16 November 2021

**Our Ref:** 210183

**BUILDING CODE OF AUSTRALIA ASSESSMENT**  
**10 LETHBRIDGE STREET PENRITH NSW 2750**

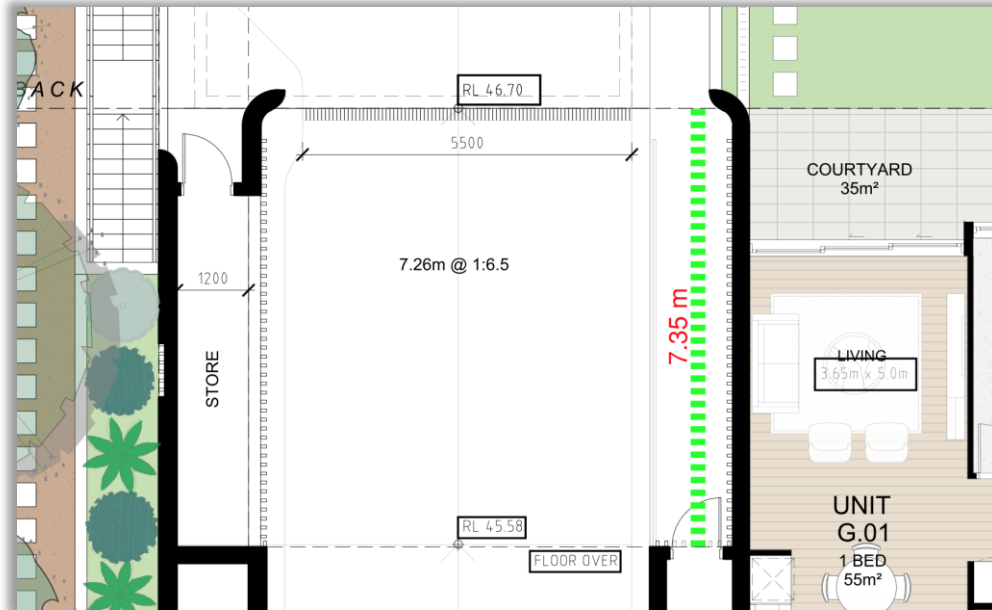
The firewall separating the carpark from the residential part of the building on the ground floor, extract below, incorporates **two fire doors** in lieu of a single fire door in accordance with Clause C3.5(a)(iii) of the BCA. Where a deemed-to-satisfy design proposal is not achieved, a Fire-Engineered Performance Solution will need to be prepared by a C10 Accredited Fire Engineer at the Construction Certificate stage to justify the non-compliance and is to address the relevant Performance Requirements of the BCA accordingly.
